ELBERT P. EPLER
NUCLEAR SYSTEMS CONSULTANT
712 FLORIDA AVENUE
OAK RIDGE, TENNESSEE 37830
483-0994

CT-1125
PDR 7/13/79
DISTRIBUTED TO ACRS MEMBERS

By letter, 5-26-79 to W. Kerr, ATWS subcommittee chairman, A. Bates has called to our attention four failures of scram breakers within a period of three weeks at Oconee Units 1 and 3. These are tabulated as follows.

The breakers are shown schematically below.

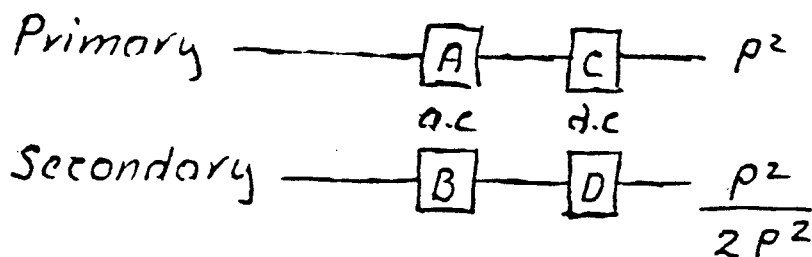
In order to scram, breakers A, or C, plus B, or D, must be tripped. Failure probabilities are as follows

This corresponds to one failure in 40 years for each breaker when tested once per month. We have seen in three weeks, four failures in a group of 8 breakers, and can not be assured that the remedy, the minor adjustment, is effective. This matter should be pursued.

Fig. 5 proposes that the relay logic be removed, that breakers be added so as to provide two independent and diverse shutdown systems. By increasing the number and diversity of breakers, their individual or common mode failure would be of less consequence.
